SFMTA - TASC SUMMARY SHEET

Location: Connecticut Street between Cesar Chavez and 26th Street

Subject: Parallel Parking

1920 Cesar Chavez Project

Attachment 2

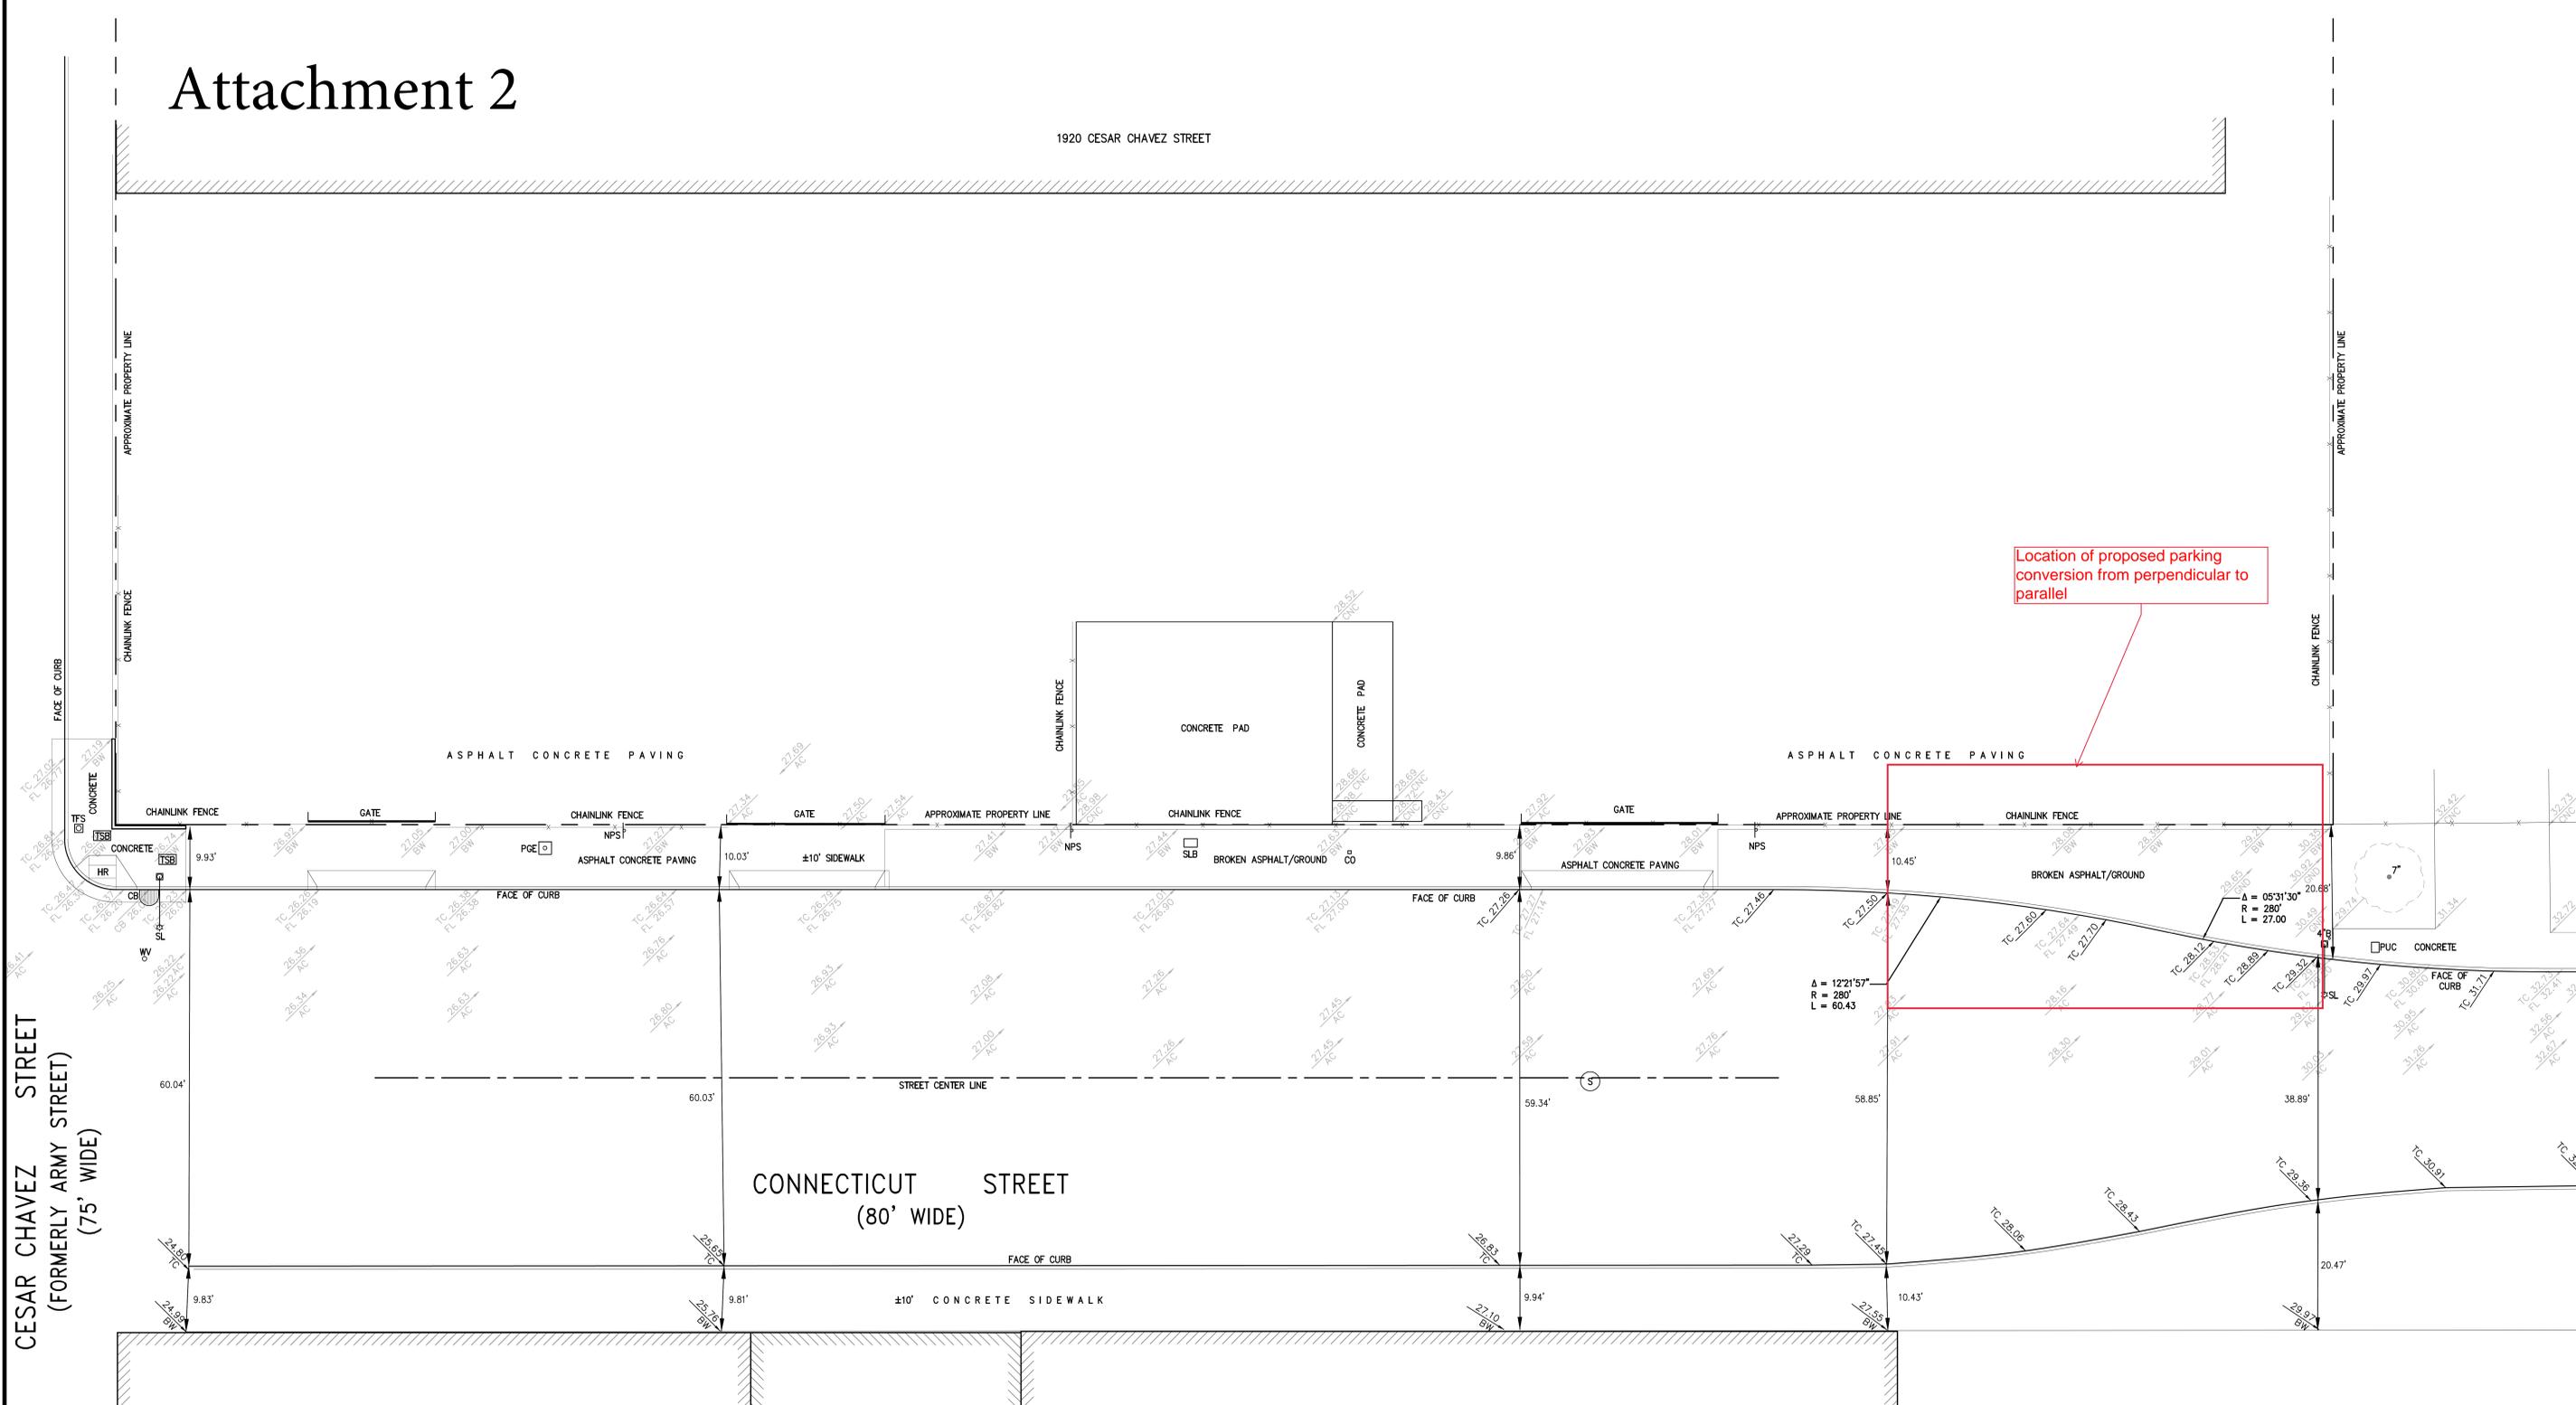
Location of proposed parking conversion from perpendicular to parallel

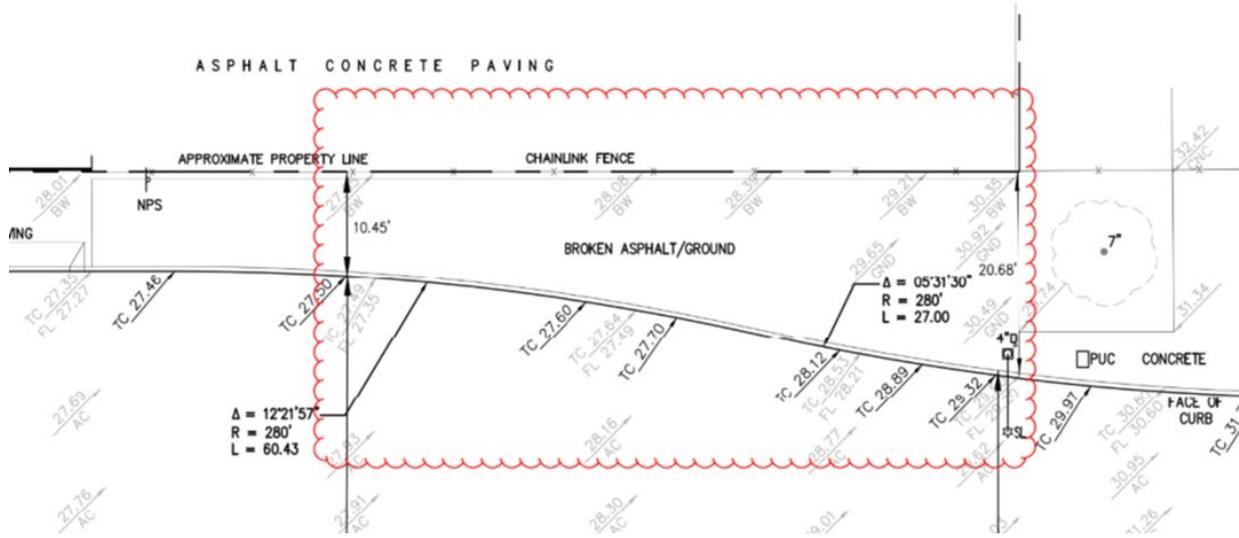
During BSM's review, a referral was sent to SFMTA who then requested confirmation from SF Fire to review the minimum roadway width. Please see Victoria's comment below regarding the concern of the roadway width at the pinch point. Please let us know your thoughts.

- Connecticut Street: Please confirm that SF Fire has reviewed these plans and approve of the minimum roadway width in the red area below, where the sidewalk widens. If cars continue to park 90-degrees in the red area, this would result in vehicles protruding more into the roadway than existing conditions. If they need more clear width, we will need to legislate the parking to be converted from 90 degrees to parallel. Note: the 90-degree parking, south of this section, will work fine since the roadway is wider from the 10.45' dimension to Cesar Chavez.

Thank you for bringing this to my attention. No, the parking in the red bubble would need to be converted.
